Reference: Hansen Tract – Foxlane Homes

My office is in receipt of a 24-sheet set of plans prepared by Holmes Cunningham Engineering. These plans are dated July 21, 2025, and have not been revised per the submission. The property known as the "Hansen Tract" is bisected by the municipal boundary of Cheltenham Township and Springfield Township. It appears that approximately ten acres of land is captured by Cheltenham Township and approximately 2.7 acres of land captured in Springfield Township. The vast majority of this proposal occurs in Cheltenham Township. Many of the structures creating the former estate property have been removed; however, a large garage and accessory structures including the residence still exist in Springfield Township. The proposal calls for the removal of these old structures and the creation of one new building lot in Springfield Township along with an area for additional stormwater management improvements. The Cheltenham proposal would create 43 new townhomes accessed by a two-way roadway connecting into Willow Grove Avenue and to a newly constructed intersection.

Re: MCPC #25-0227-001
Plan Name: Hansen Tract
(1 lot comprising 2.7 acres)
Situates: Sandy

Drawing No.
C1.0

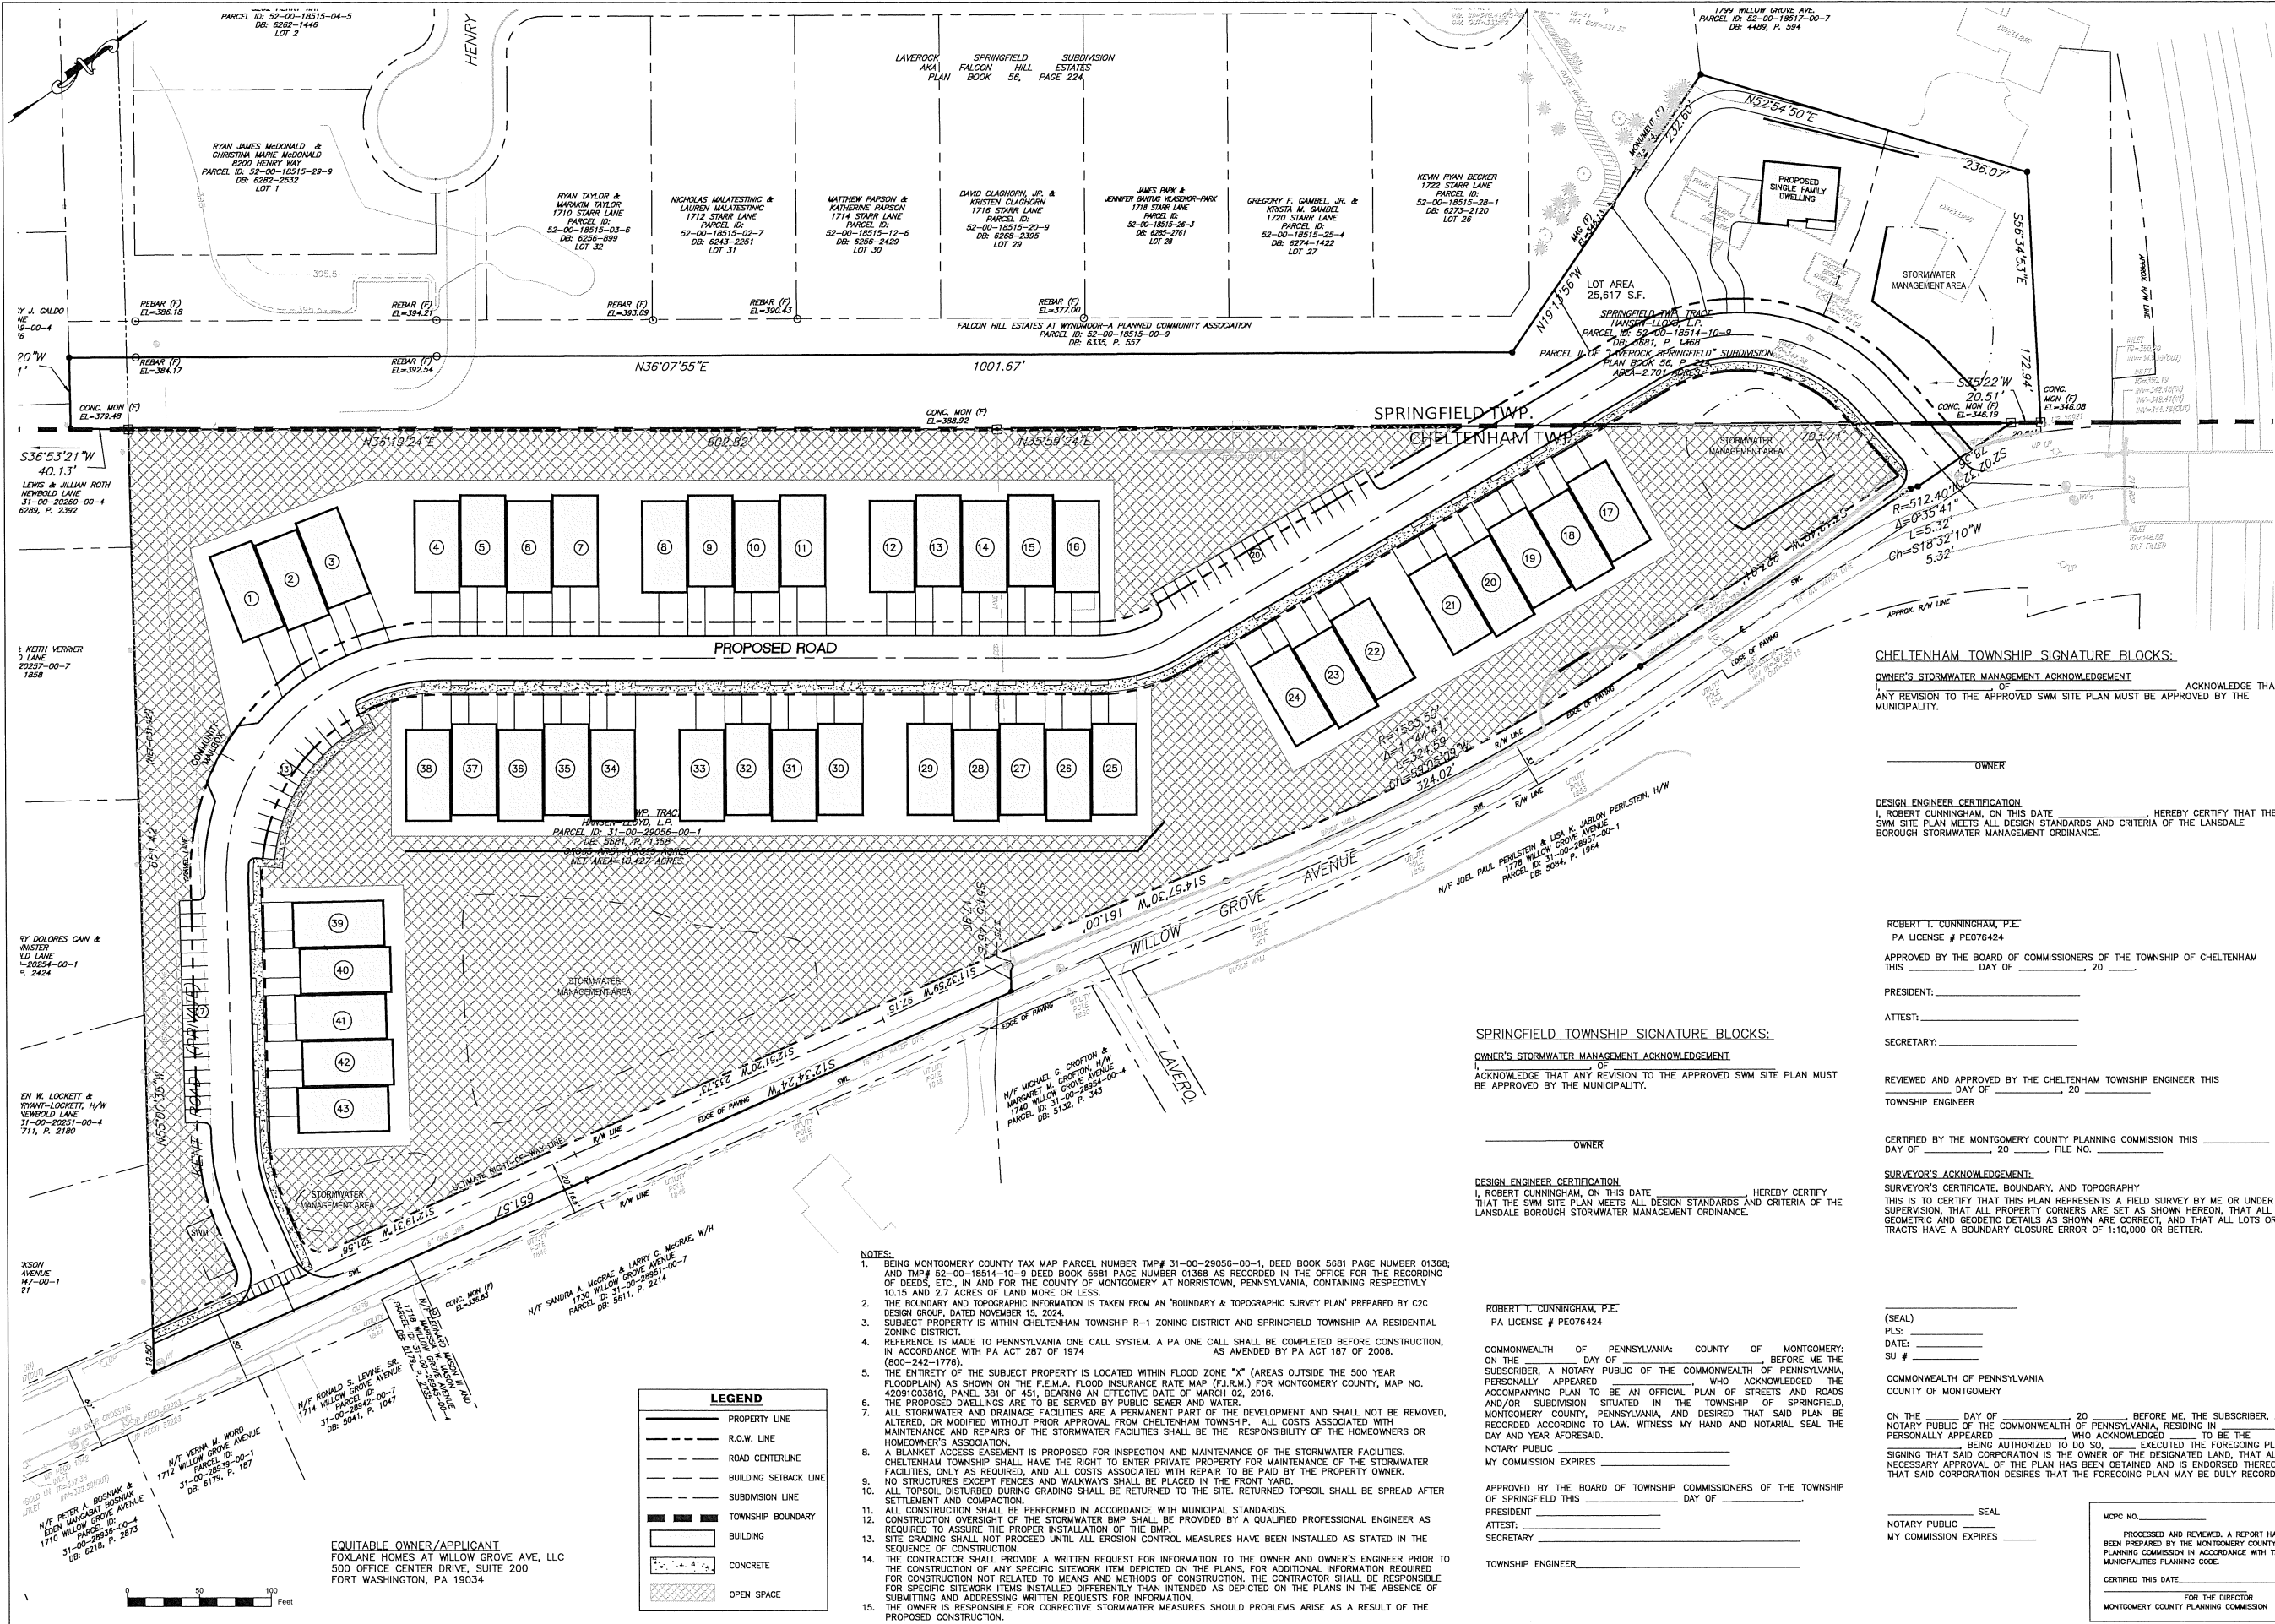
8. The Design Engineer certification on sheet C1.0 lists Lansdale Borough, please revise.
9. Plan sheet C2.0, note #3, references Middletown Township, please revise.
